**EXHIBIT LIST FOR SUB 2025-004/EA 2025-016  
Preliminary Plat of Cottonwood Canyon**

### STAFF REPORT TO THE BENTON COUNTY PLANNING COMMISSION

**FILE NO:** SUB 2025-004 – Preliminary Plat of Cottonwood Canyon

PRELIMINARY PLAT  
COTTONWOOD CANYON  
W 1/2 OF SEC. 15, T.08N., R.28E., W.M.,  
BENTON COUNTY, WASHINGTON

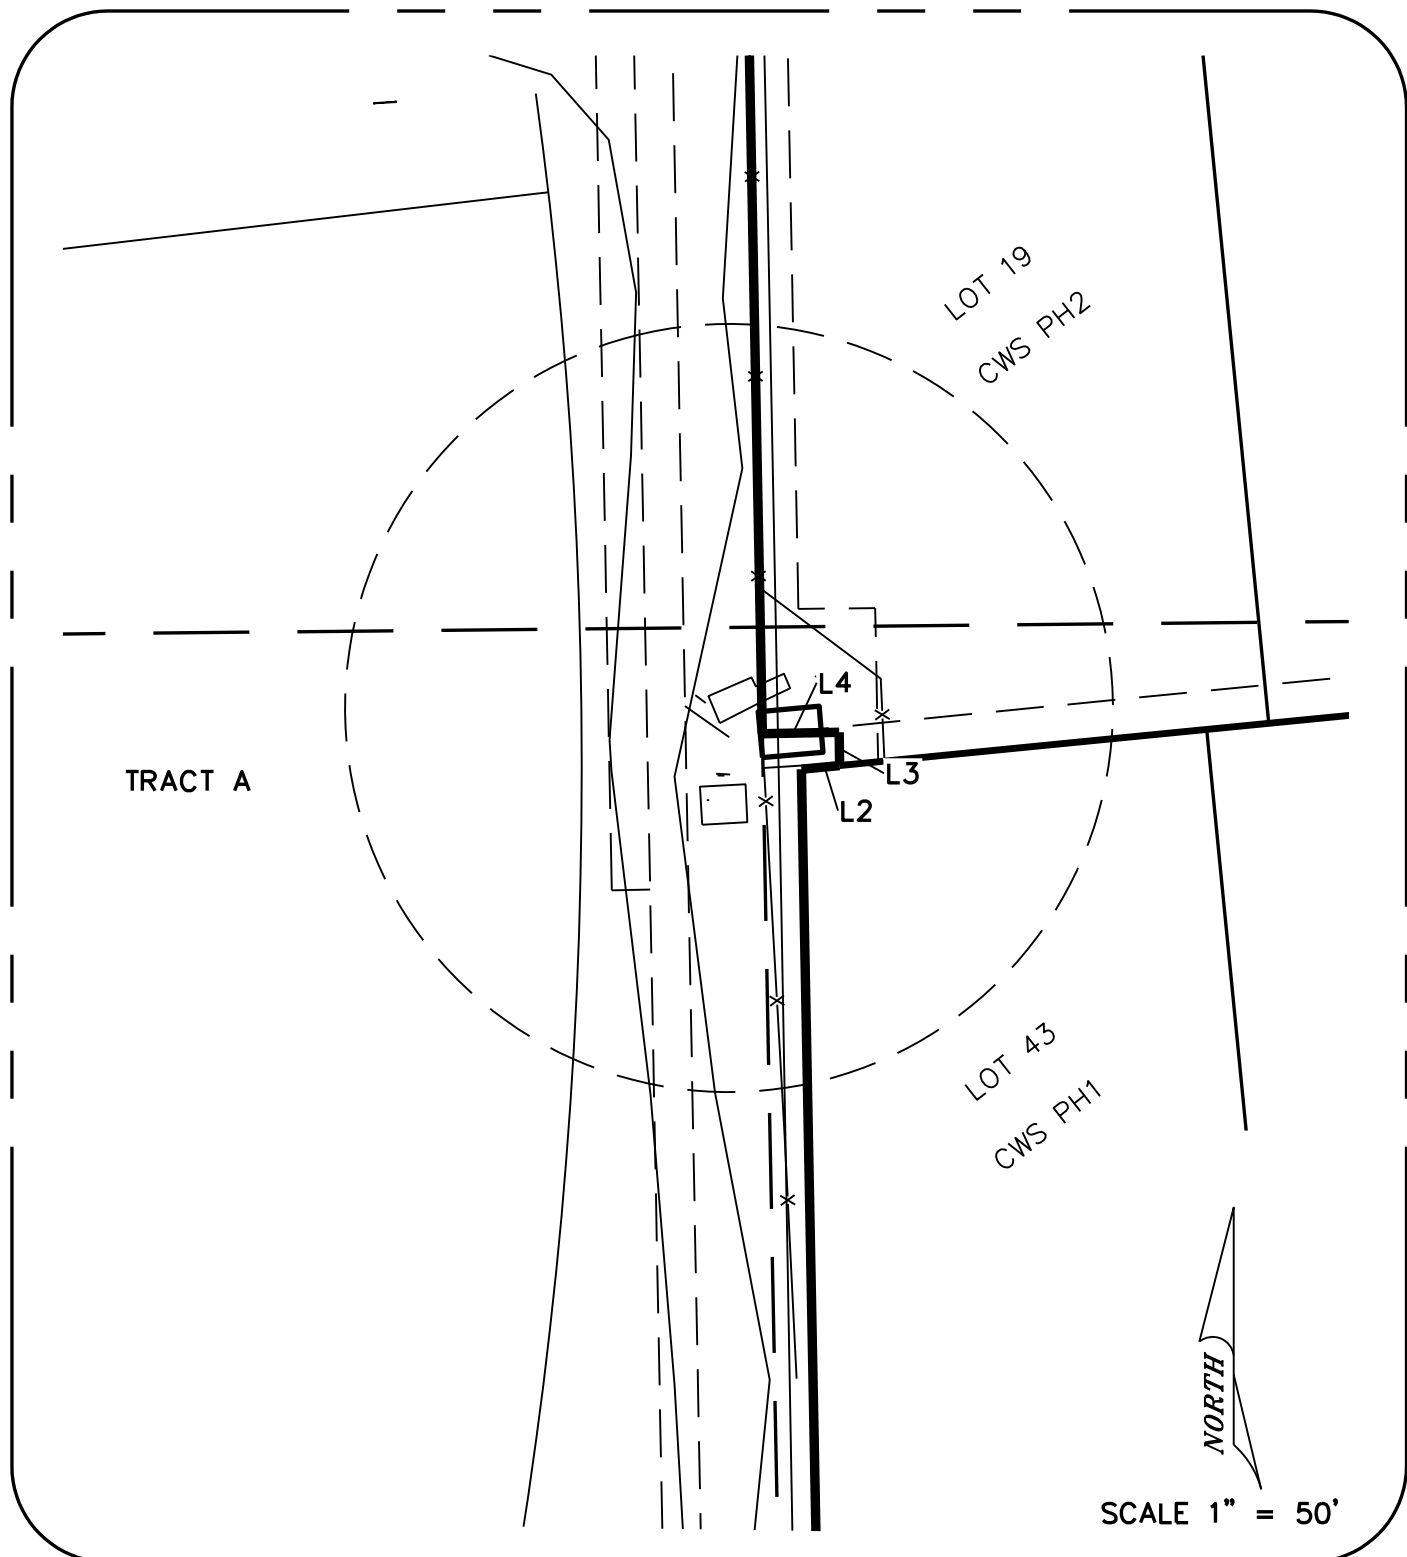
- l. Dedicate 60' of right of way to Benton County for road purposes. (The plan shows 30 feet each side of centerline with no description of what the 30 feet is for)

- q. Change the name of Thayne's Way to Bermuda Rd.
  - r. Install type 3 barricade at north end of "Thayne's Way" after construction of road and prior to recording Phase 3.

- t. After final approval of the road construction for each phase, one full size Mylar of the record drawings shall be provided to Public Works.
  - u. The current preliminary plat does not show areas for on-site retention of storm water runoff. Pending the final hydrology report additional areas for on-site retention may be required to be added to the final plat.

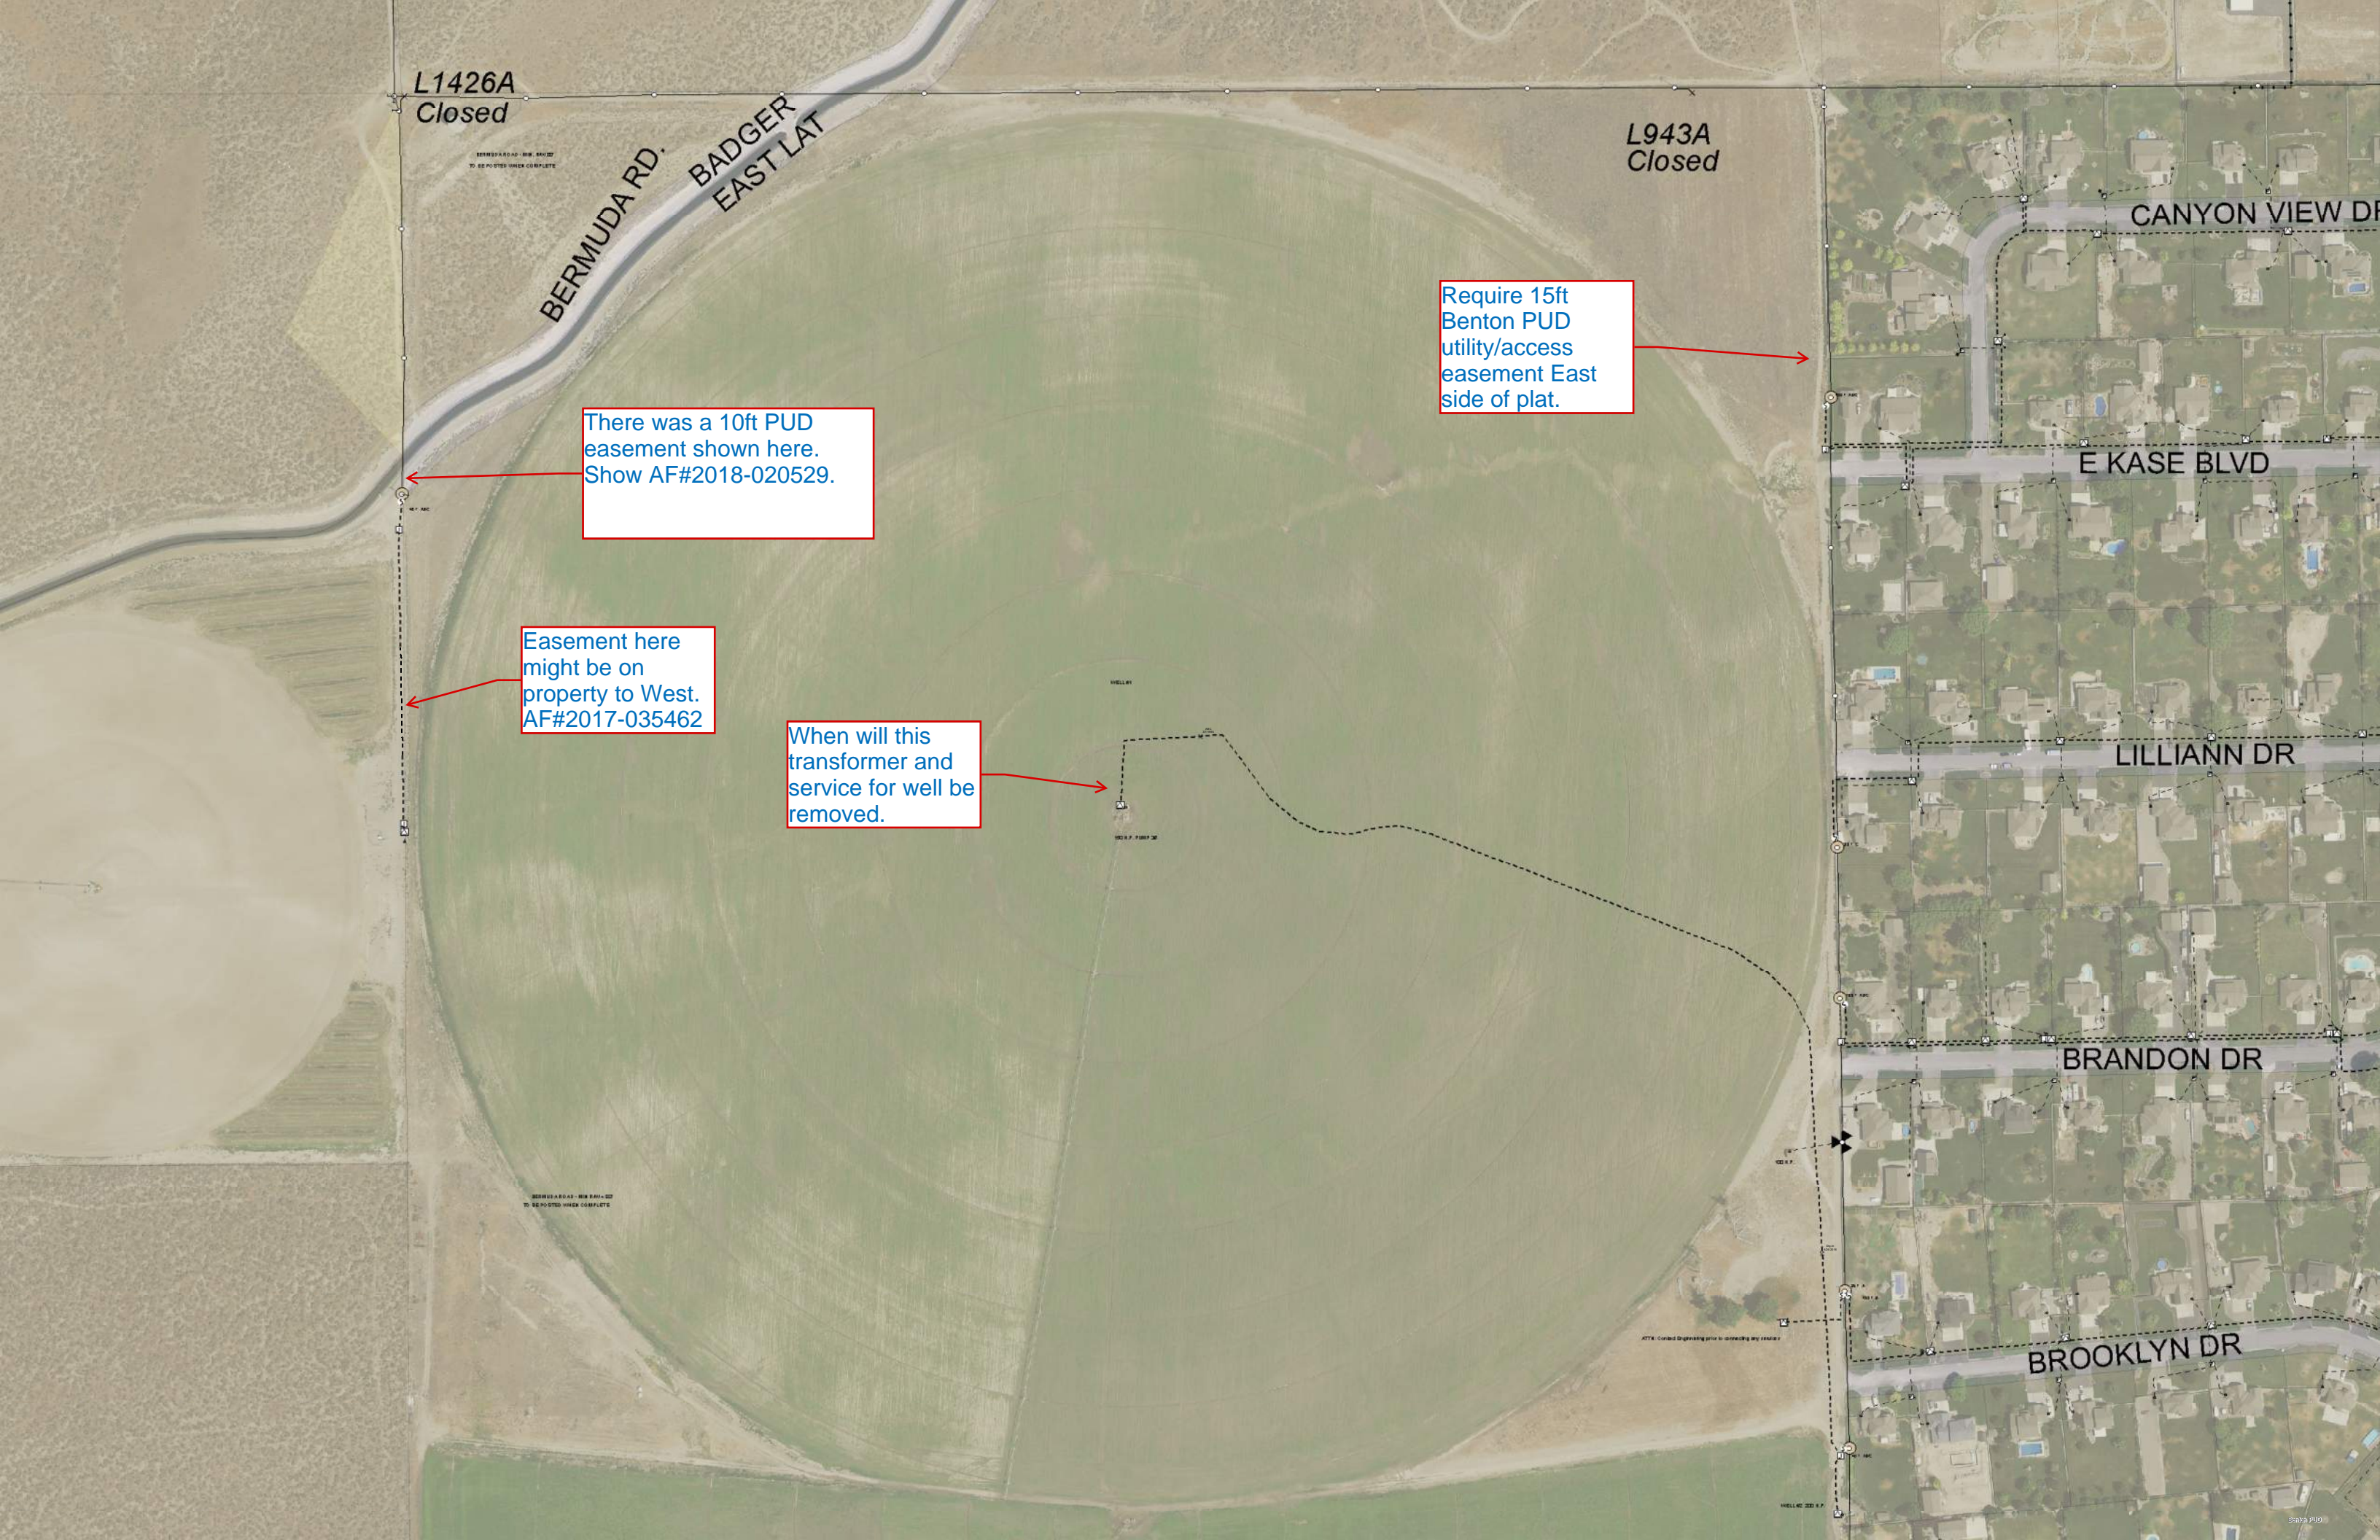
There was a 10ft PUD  
easement shown here.  
Show AF#2018-020529.
